Access Compliance Report

Public Rights-of-Way

(Curb Ramps)

Intersection ID: 11676	Main Street: HAWTHORNE_LN	Cross Street: PARKWOOD_AV	Location: NE
ADA ID: 61AB69987660	Ramp Type: Perp	Initial Pass/Fail: Fail	Overall Compliance: No
		Severity Score: 10

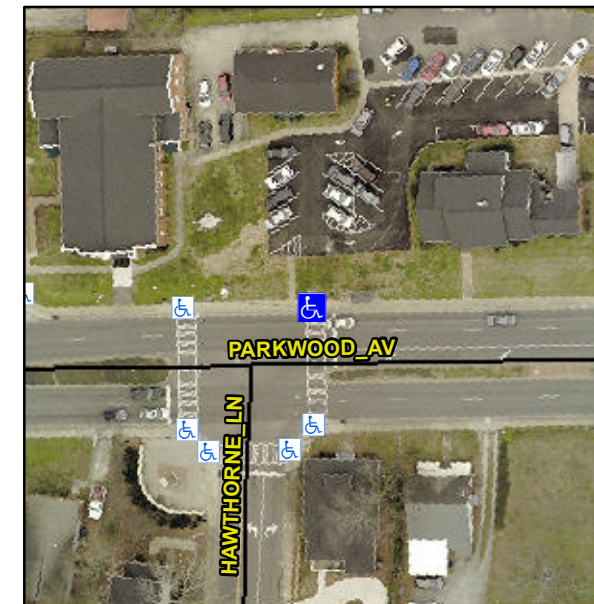
Not Found, R304.5.1

Compliance	Description	Data	Compliance	Description	Data
N/A	Ramp Length (in)	60.0	Yes	Ramp Slope (%)	7.4
No	Ramp Width (in)	47.5	Yes	Ramp XSlope (%)	2.3
N/A	Flare Type LT	N/A	N/A	Flare Type RT	N/A
N/A	Flare Slope LT (%)	N/A	N/A	Flare Slope RT (%)	N/A
N/A	Flare Traversable LT?	N/A	N/A	Flare Traversable RT?	N/A
N/A	Landing Length (in)	N/A	N/A	DWS Provided?	N/A
N/A	Landing Width (in)	N/A	N/A	DWS Contrast?	N/A
N/A	Landing Slope (%)	N/A	N/A	DWS Length (in)	N/A
N/A	Landing X Slope (%)	N/A	N/A	DWS Full Width?	N/A
N/A	Landing Curb? (Y/N)	N/A	N/A	DWS Offset (in)	N/A
N/A	Shared Landing?	N/A			
N/A	Gutter Ponding?	N/A	N/A	Gutter Slope (%)	N/A
N/A	Gutter Lip Ht (in)	N/A	N/A	Gutter X Slope (%)	N/A
N/A	Painted X Walk1?	Yes	N/A	Painted X Walk2?	N/A
	X Walk 1 Direction	To S		X Walk 2 Direction	N/A
N/A	X Walk 1 Width (in)	104.0	N/A	X Walk 2 Width (in)	N/A
	X Walk 1 Slope (%)	2.0		X Walk 2 Slope (%)	N/A
	X Walk 1 X Slope (%)	2.3		X Walk 2 X Slope (%)	N/A

Remove & Replace Entire Ramp.
